DEPARTMENT OF THE ARMY

LOS ANGELES DISTRICT CORPS OF ENGINEERS
P.O. BOX 532711
LOS ANGELES, CALIFORNIA 90053-2325

Thank you for your participation and interest in this project and concerns related to the project features and their potential impacts to the surrounding community and environment. I am responding to your comments on the Matilija Dam Ecosystem Restoration Project that were provided to me through Mr. Doug Chitwood. We have prepared a response to each of your comments listed below.

Figure 1. Comparison of change in thatweg elevation between 2001 and 1970. Negative changes indicate areas of degradation in the channel bed. Positive changes indicate areas that have aggraded. Areas within 2.5 feet of change are considered to be within the error range of the 1970 data.

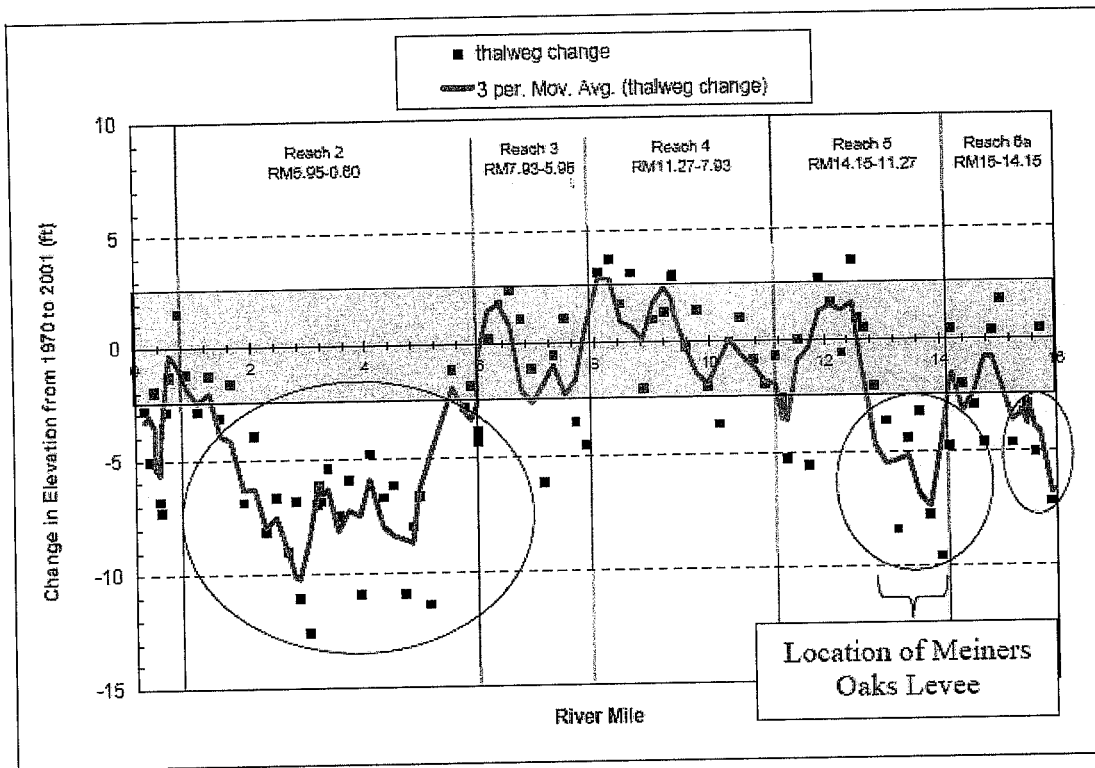
Meiners Oaks Levee Design: The attached figures show the analysis results for existing 100-year flooding threat, future flooding with dam removal, and intended flood mitigation with the proposed levee. The with-project flood predictions are absolute worst case scenario: the 100-yr flood occurs immediately after dam removal. Inflow from upland tributaries was not included in these analyses. It is noted that the most recent analysis predicts a higher flood potential (both with- and without-project) than the Feasibility Study analysis. The analysis shows an incremental increase in flooding with dam removal in the worst-case scenario.

What changed in the more recent models? How does this analysis compare with the existing FEMA flood map? How does the flood risk change over time following dam removal?

The natural re-supply and sediment eroded from the reservoir deposits will cause deposition in this reach after dam removal. The 100 year water surface elevations will increase up to 9 feet immediately below Robles Diversion Dam. There has been 5 to 7 feet of degradation in this area since 1970 (see Figure 1), and there was probably additional erosion in this area from the time of the construction of Robles Diversion Dam (1958) to 1970. Therefore, the riverbed in this reach will return to approximately its pre-dam elevations. We do not expect that the flood elevations will decrease to current conditions because the current condition is a degraded state caused by the trapping of sediment behind Matilija Dam. The natural resupply of sediment will return the Ventura River to pre-dam conditions, which in many reaches means an increase in flood elevations.
